Date: 3/7/2004

T10: T10 Technical Committee (SCSI)

From: Charles Binford, Sun Microsystems, Inc., (charles.binford@sun.com)

Subject: Target Multiport Model

Figure X

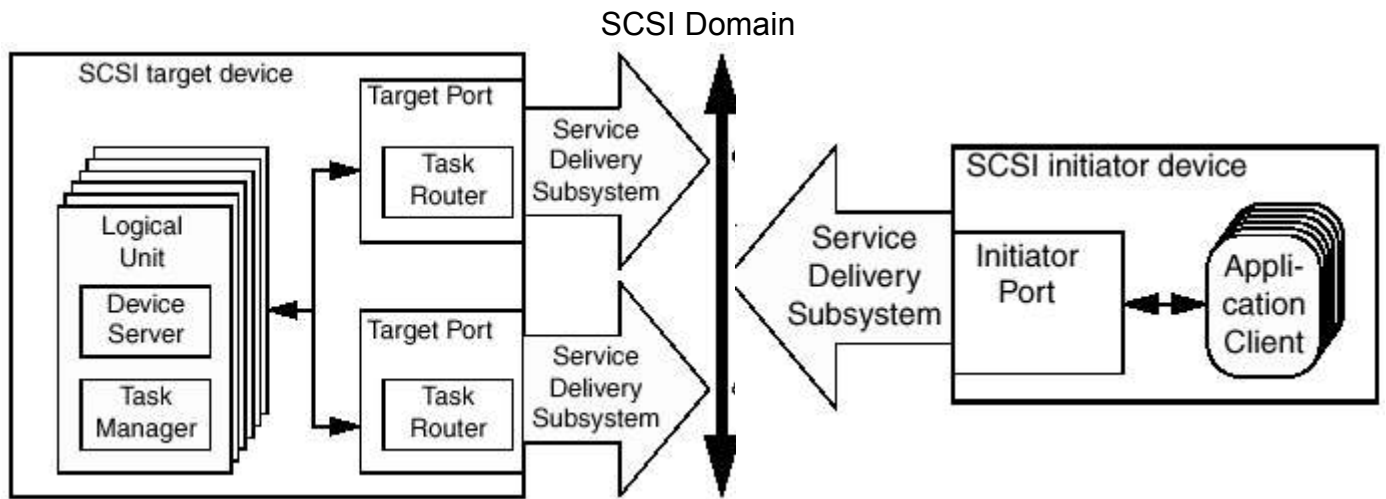
Based on discussion from last CAP meeting, I believe we also need a diagram that shows the following configuration:

The key question this figure will answer is how many “initiators” does the target see? Should the target differentiate this from figure 21 above?

No where can I find language that directly applies to Figure X. However, the following text addresses the Figure X from the Initiator's point of view.

I maintain that the target and initiator **MUST** have the same view of the world. Thus, if the initiator device can't tell if Figure X is a single target device with multiple ports or two separate target devices, then to preserve the semantics of task management and reservations the target must treat Figure X configurations as two separate initiators.

For a redundant array controller configuration, having a device server view Figure X as two separate initiator ports allows for a much looser coupling of the task sets when TST=001b or Qerr=11b.
